Re: Wander Village Plan 1 Amendment 2 (major)

Village Plan Amendment 2

Jordan Promenade (Wander) Village Plan 1

**AREA 1 VILLAGE PLAN
AMENDMENT 2**

**LOCAL ROADWAY (59' ROW)****PRIVATE ROADWAY (min. 45' ROW)**

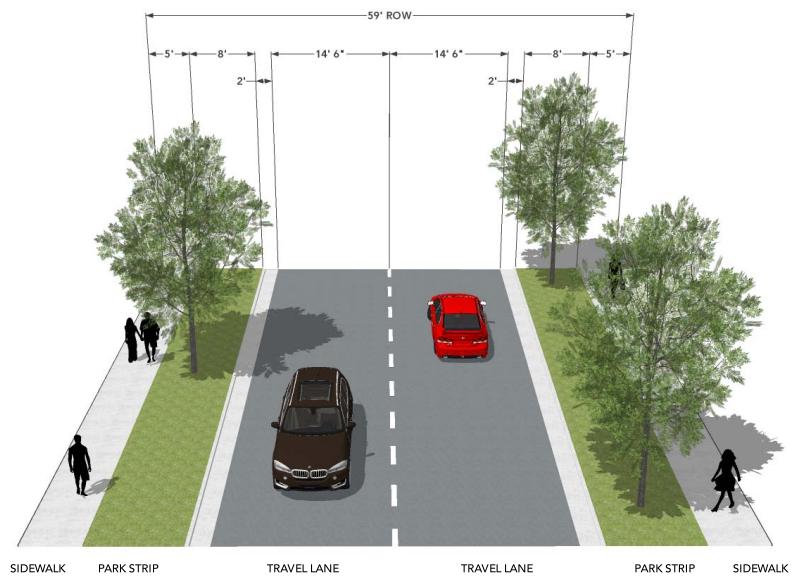
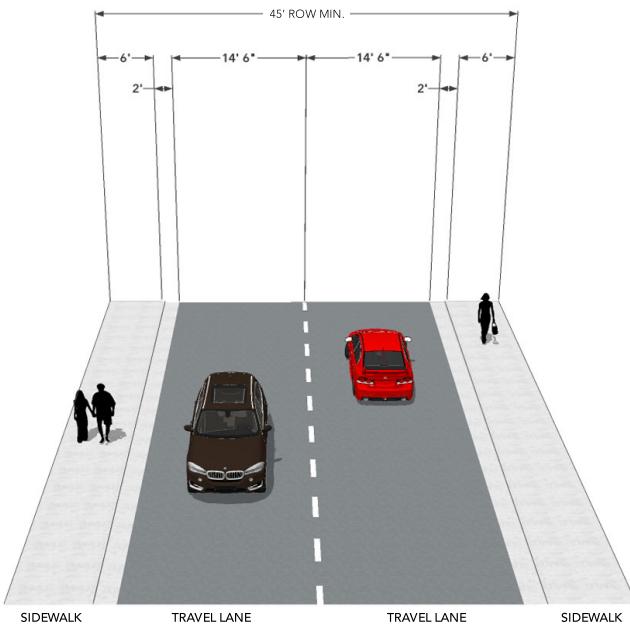
Page 83: Adding a Private Roadway cross-section.
